Date : JUNE 1, 2026

Re : **CARENCRO CITY HALL EXPANSION**
**Carencro, Louisiana**

Project No: 2024.006

# ADDENDUM № 5

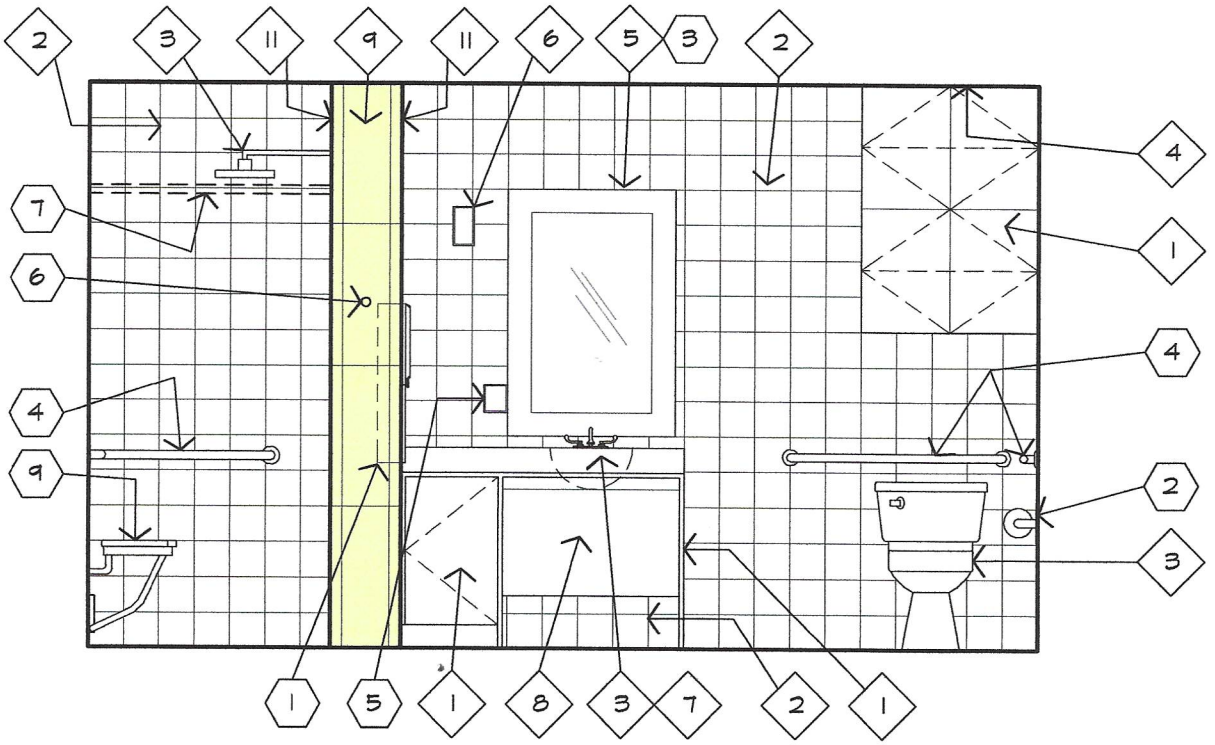
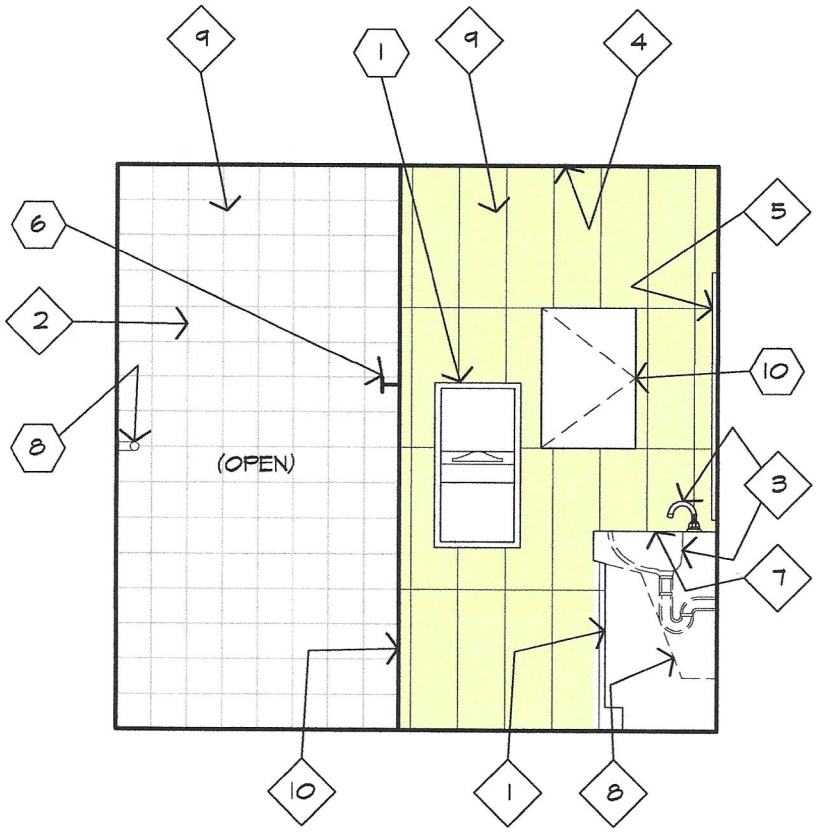
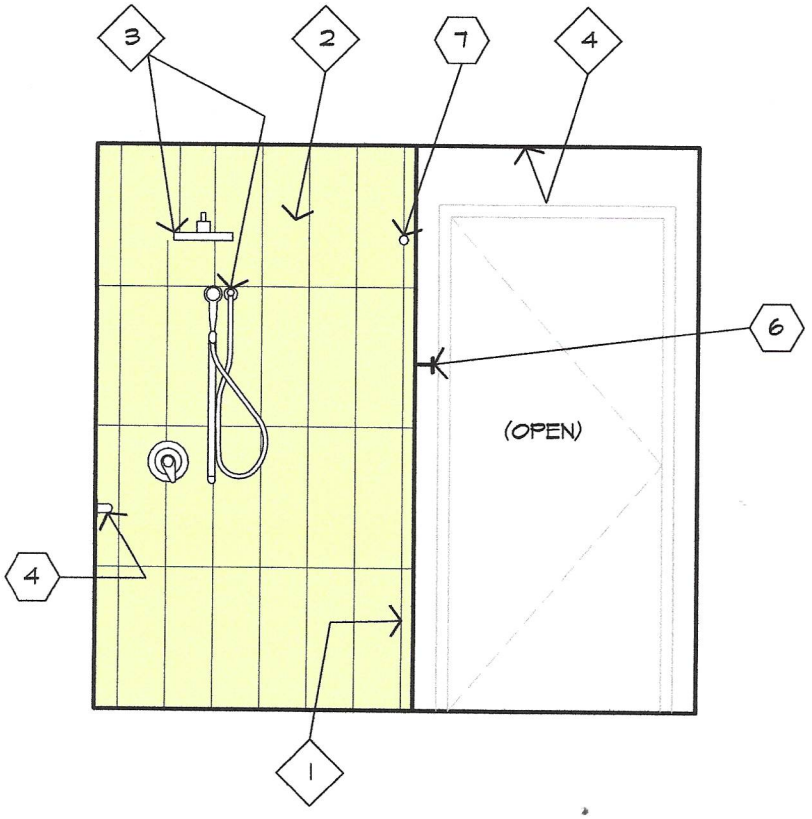
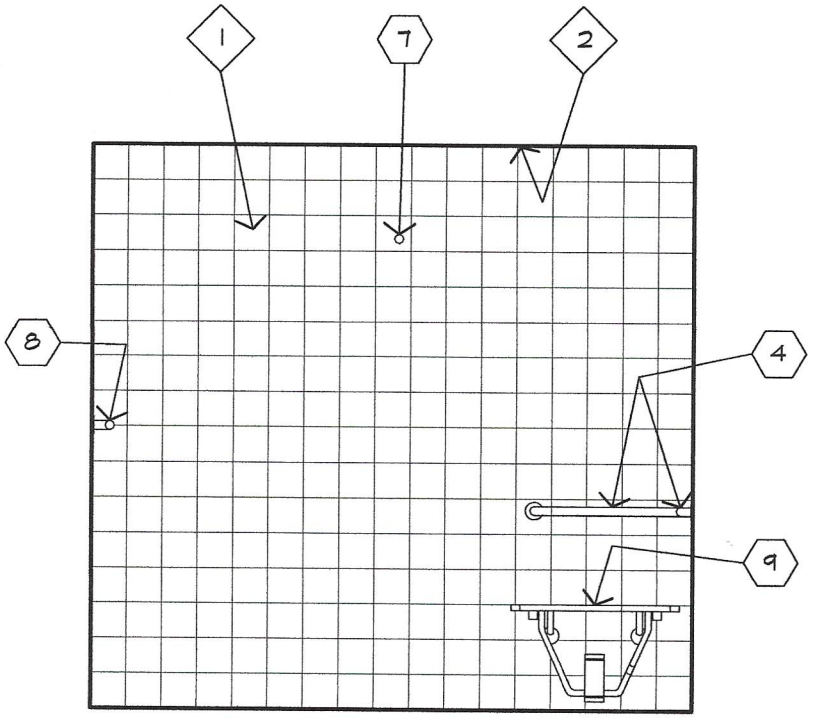
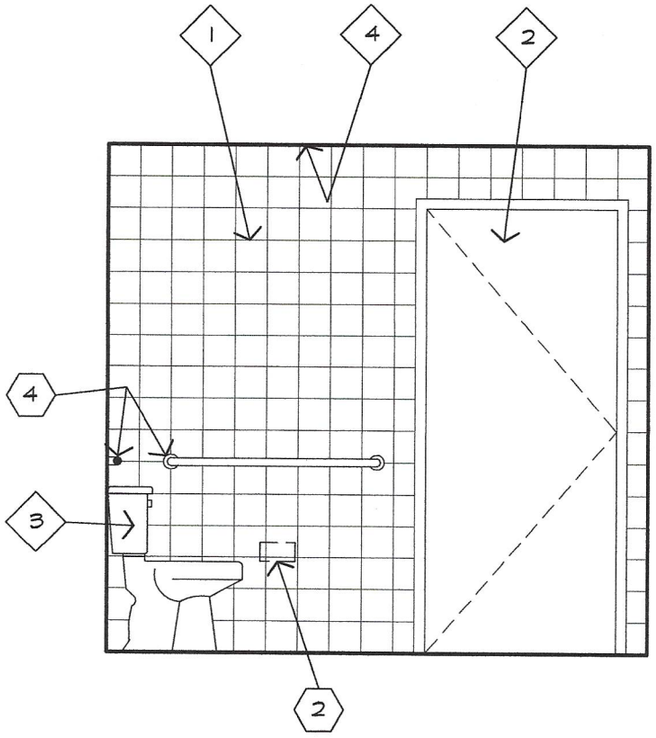
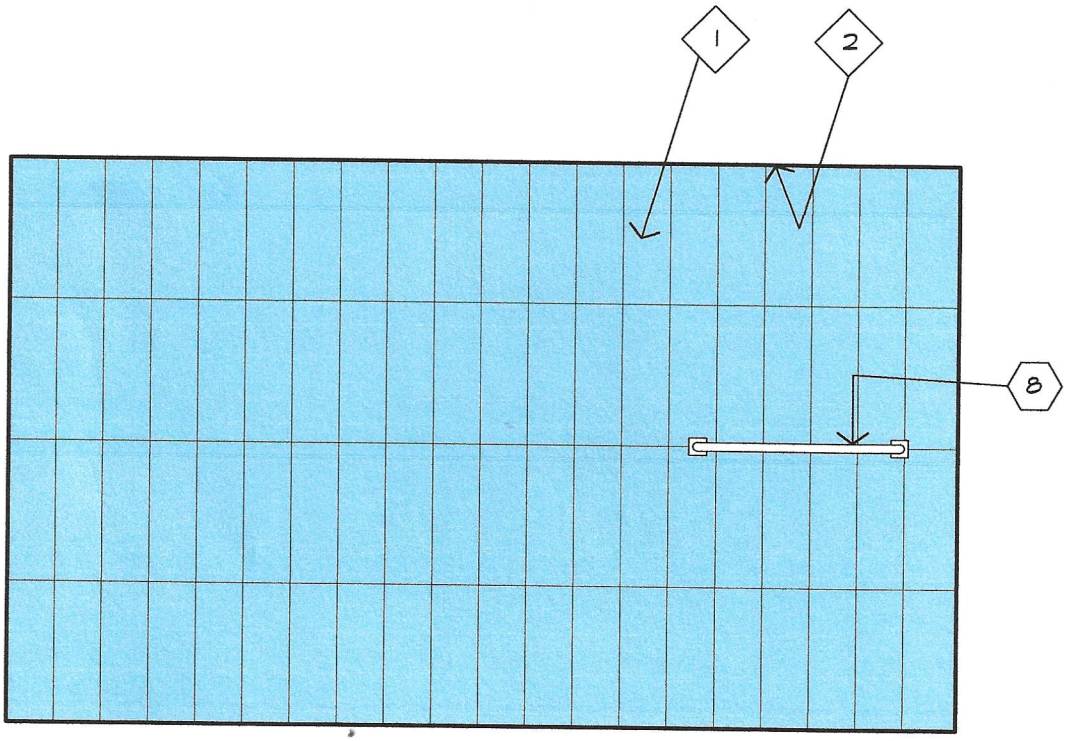
g. Sheet A.602 –
   i. Drawings A.10, D.10, and D.12 are hereby replaced and additional interior elevations of room 215 are hereby added. See Attachment No. Four (4).

# REVISED OPENING "A"

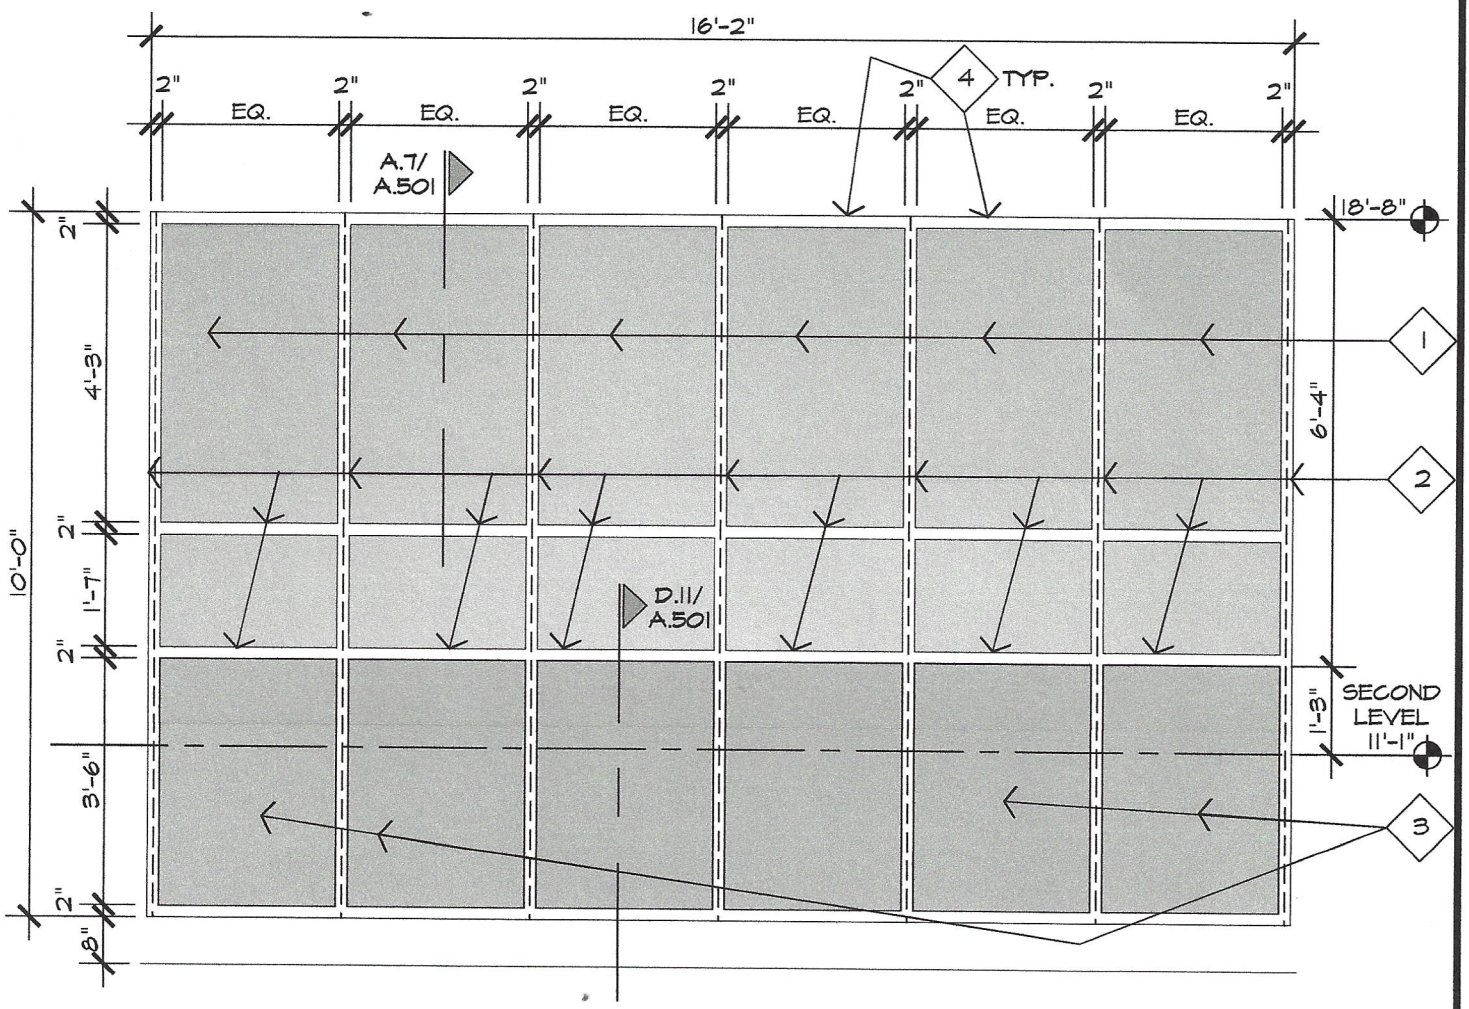
a. Sheet A.000 –
   i. Opening "A" is hereby revised as shown on the attached drawing labeled "Revised Opening "A"", and dated June 1, 2026. See Attachment No. Five (5).

1. SOLAR GRAY INSULATED GLASS; MATCH EXISTING GLASS ON BUILDING. ***
2. BLACK ANODIZED ALUMINUM STOREFRONT AND DOOR. MATCH EXISTING. ***
3. SOLAR GRAY INSULATED SPANDREL GLASS. ***
4. PROVIDE STEEL REINFORCING IN VERTICAL EXTRUSIONS TO MEET DESIGN FOR WIND LOADS.

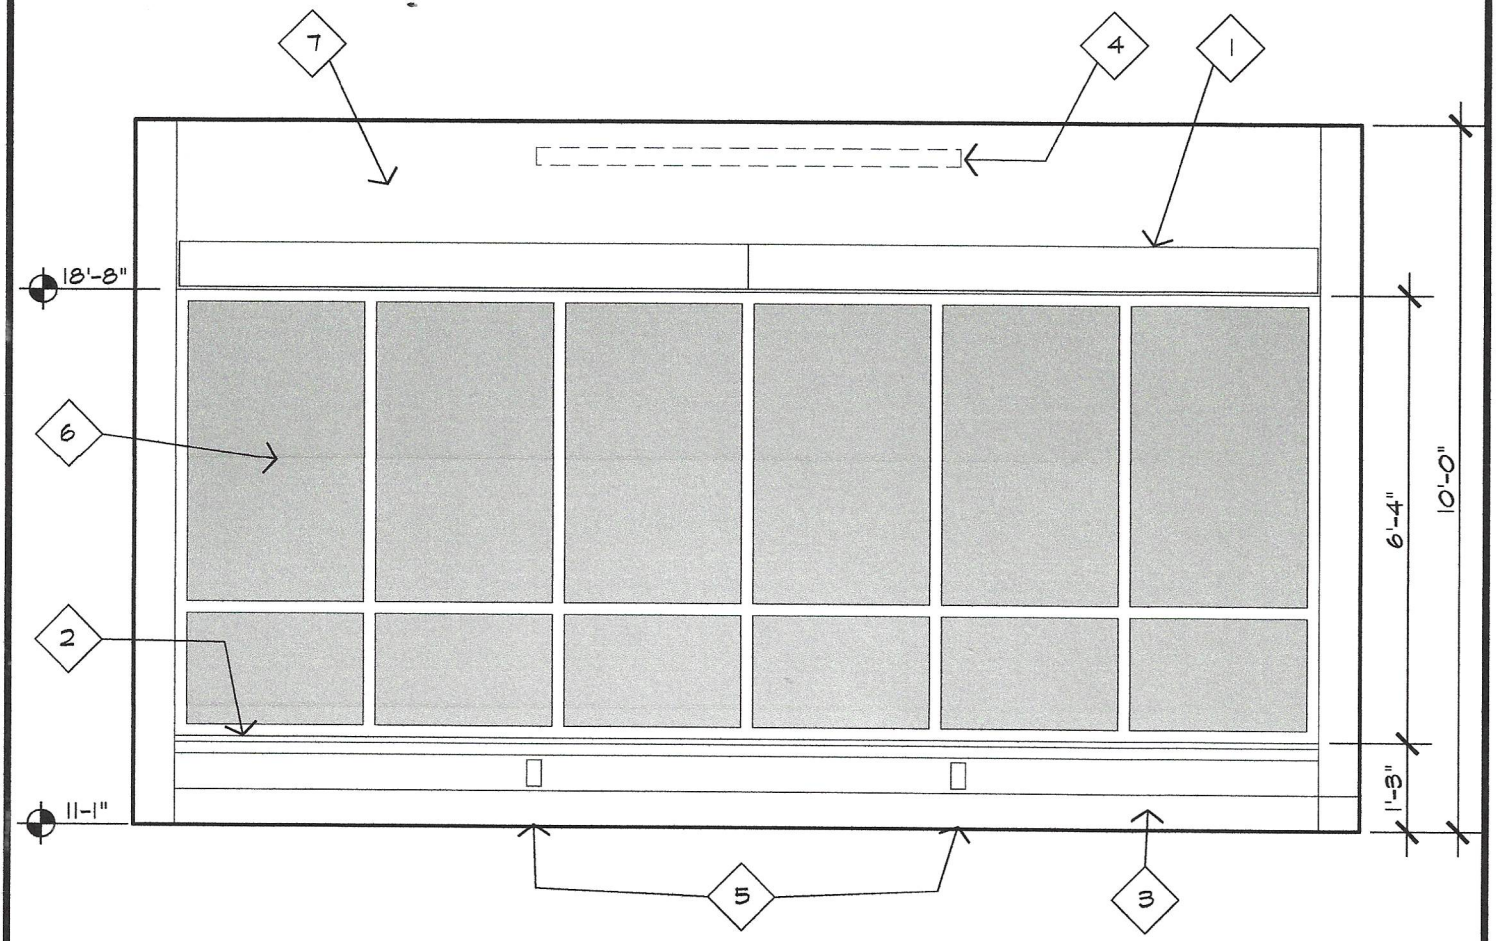
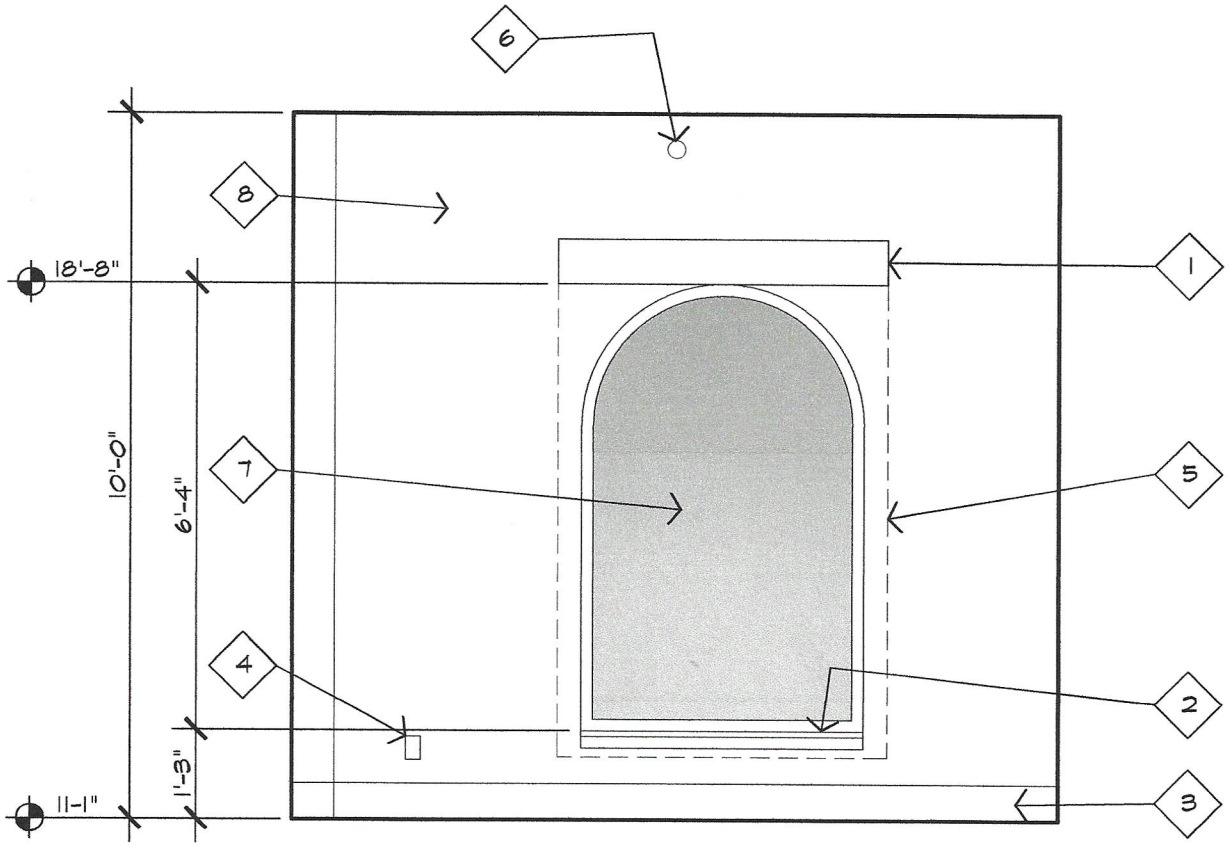
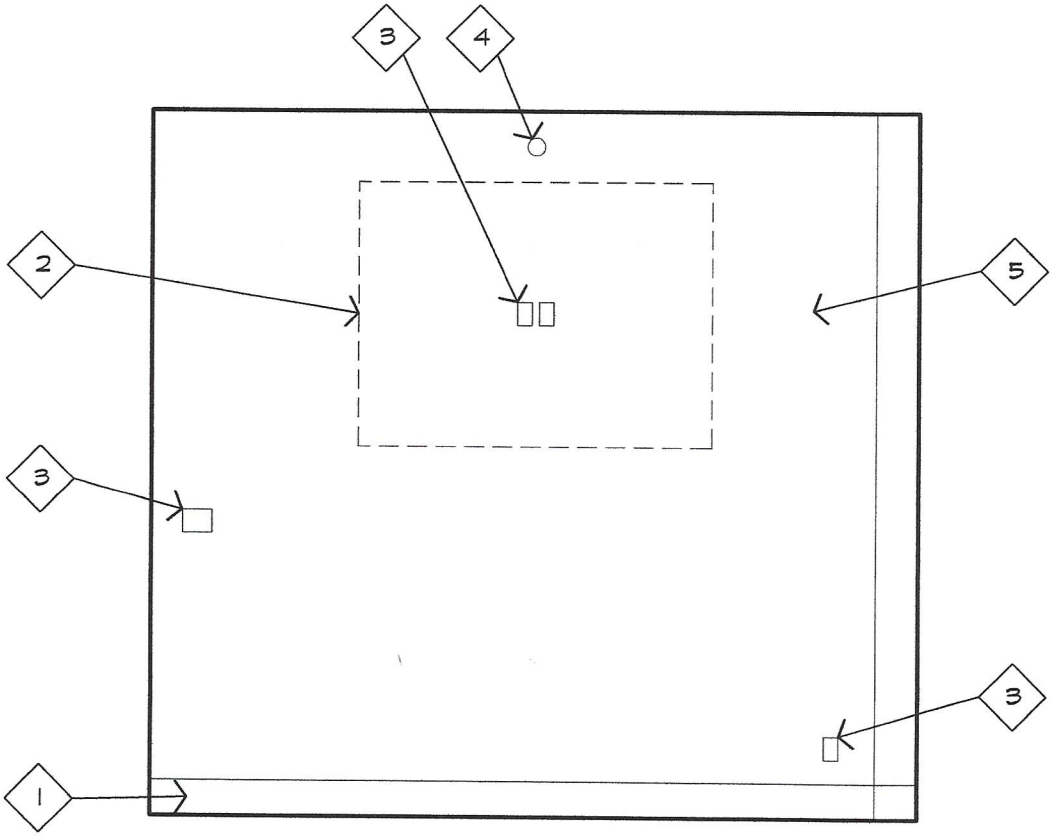
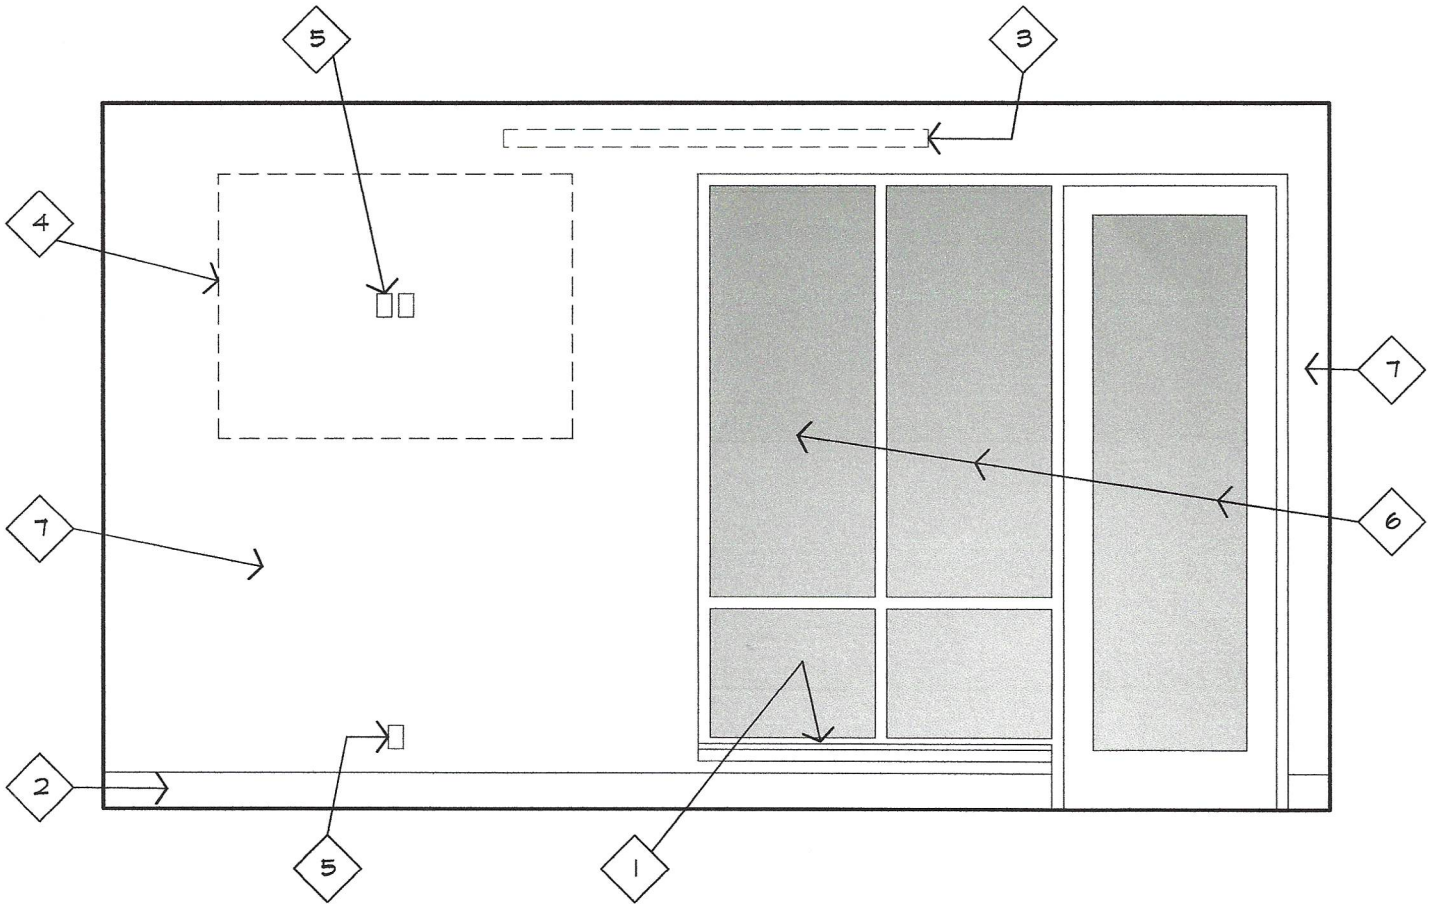
f. Sheet A.601 –
   i. Four interior elevations of Conference Room 225 are hereby added. See Attachment No. Six (6).
